CITY OF SMYRNA

MEMORANDUM

RE: **VARIANCE CASE V21-026**
1607 Walker Street – Allow impervious surface area to increase from 45% to 48.8%

Figure - 2
Proposed Site Plan

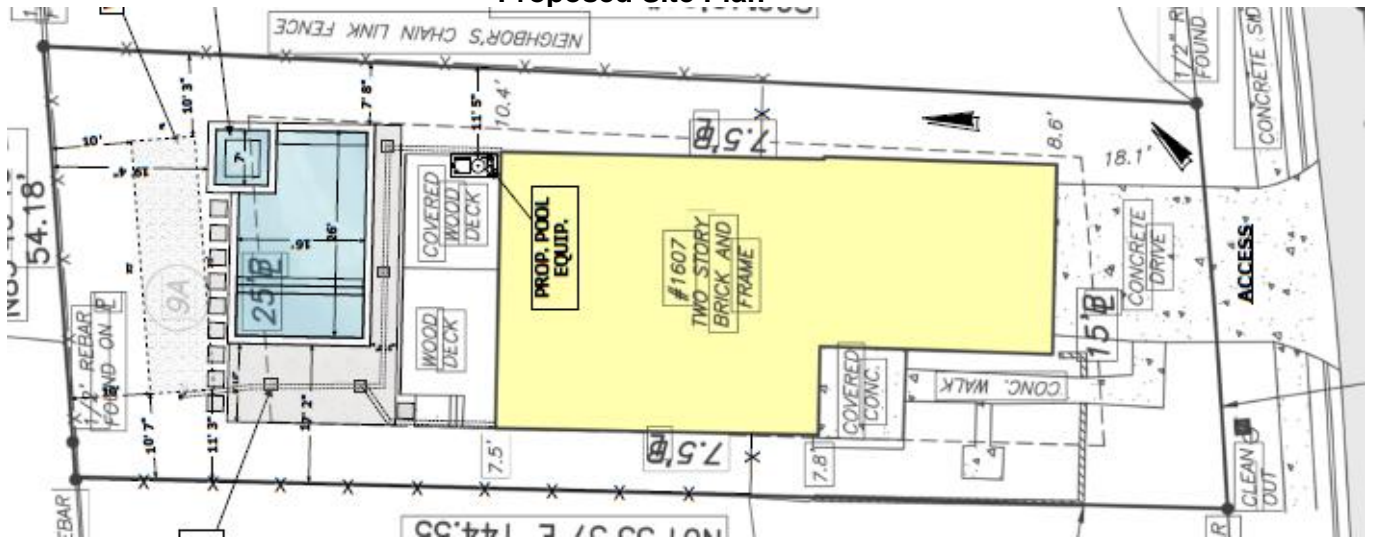
The applicant is proposing to build a 465 square foot in-ground pool with spa in the rear of the property. Due to the proposed swimming pool and size of the lot, the impervious surface area will be above the allowable 45% by 3.8%. To offset the increase in impervious surface area, the applicant is proposing a mitigation plan involving a gravel trench in the far rear of the property. This gravel trench will replace the existing gravel trench currently in the northwest corner of the property and accounts for the increase in impervious surface area. The City Engineer has reviewed the mitigation plan and is supportive of the variance with the stipulation that #6 and #7 shown on the mitigation plan's water quality notes is completed prior to building permit issuance. According to the submitted mitigation plan, water quality note #6 reads, "Contractor to perform soil boring in center of stormwater management basin to verify seasonal high water table meets minimum two (2) foot separation between bottom of soil media and seasonal high water" and water quality note #7 reads, "Contractor to provide a percolation test to verify water absorption rate of native soil has a minimum infiltration rate of 0.5 in/hr or more".

The applicant is requesting to deviate from the development standards established by the City to increase the impervious surface area from 45% to 48.8%. According to Section 1403 of the Zoning Ordinance, variances must be reviewed under the following standards: (1) Whether there are unique and special or extraordinary circumstances applying to the property; (2) Whether any alleged hardship is self-created by any person having an interest in the property; (3) Whether strict application of the relevant provisions of the code would deprive the applicant of reasonable use of the property; and (4) Whether the variance proposed is the minimum variance needed. Community Development has reviewed the request against the variance review standards and found it to be in compliance with four (4) of the four (4) standards. After a review of the standards above, Community Development believes that the increased impervious coverage will not adversely affect surrounding residents; therefore, staff recommends **approval** of the requested variance with the following conditions:

1. Approval is conditioned upon substantial compliance with the site plan submitted with the variance application.
2. The applicant shall complete items #6 and #7 shown on the mitigation plan's water quality notes prior to building permit issuance.
 - a. Water Quality Note #6: Contractor to perform soil boring in center of stormwater management basin to verify seasonal high water table meets minimum two (2) foot separation between bottom of soil media and seasonal high water.
 - b. Water Quality Note #7: Contractor to provide a percolation test to verify water absorption rate of native soil has a minimum infiltration rate of 0.5 in/hr or more.
3. The applicant shall submit a plat revision for recording, reflecting the new location of the stormwater detention facility prior to the final inspection.
